Transitioning from the CS4382 to the CS4382A or CS4385

1. Introduction

Figure 1. CS4382 pinout

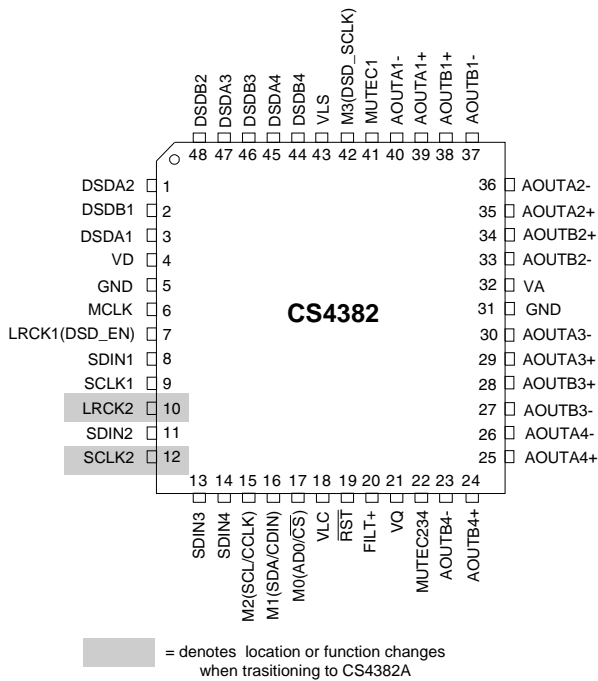
Figure 1 and Figure 2 show the CS4382 and CS4382A pinouts respectively. The changes to the two pinouts are highlighted. Figure 1 highlights the pins which have changed function and which may require a PCB change. Figure 2 highlights the pins which have new recommended components.

Location or function changes as denoted in Figure 1 are as follows:

- The CS4385 does not support the simultaneous synchronous sample rate function of the CS4382. Pins 10 and 12 are now Test inputs.

Figure 2. CS4382A pinout

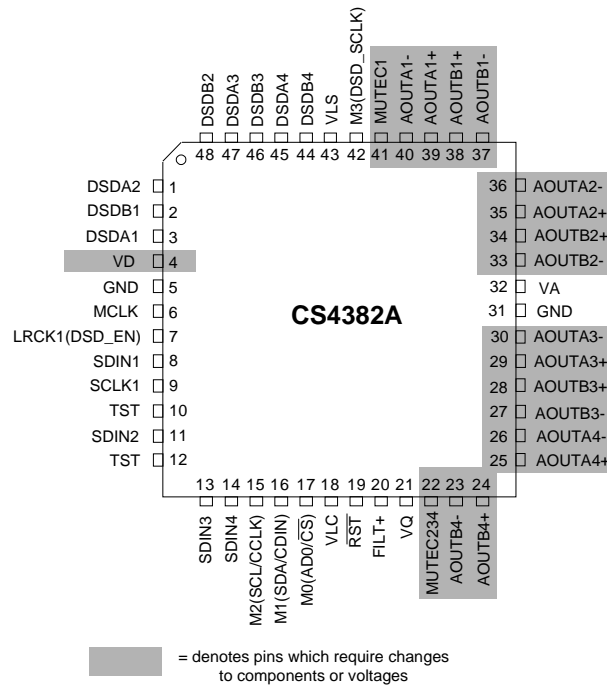
Pins which require changes to external components or voltages as denoted in Figure 2 are as follows:

- Pin 4 (VD) requires 2.5 V for recommended operation. The CS4382 used either 3.3 V or 5 V, which, if left unchanged, would damage the CS4382A.
- Pin 22 (MUTEC234) and pin 41 (MUTEC1) require an additional pull-up or down in order to mute during reset. While reset is asserted these pins are high impedance and will not drive the mute circuitry. It is recommended that the pull-up/down resistance properly biases the off-chip mute circuit into muting.

- Pins 23 - 30, 33 - 40 (AOUTs) have a new recommended filter circuit. This filter uses the same filter topology as the CS4382. The component values have been changed to account for the extra output level from the CS4382A and still provide 2 V_{rms} on the output. A general optimization was also made in order to reduce the thermal noise contribution of the resistances (using smaller resistances where possible). Please refer to the CS4382A datasheet for details on the new recommended filter.
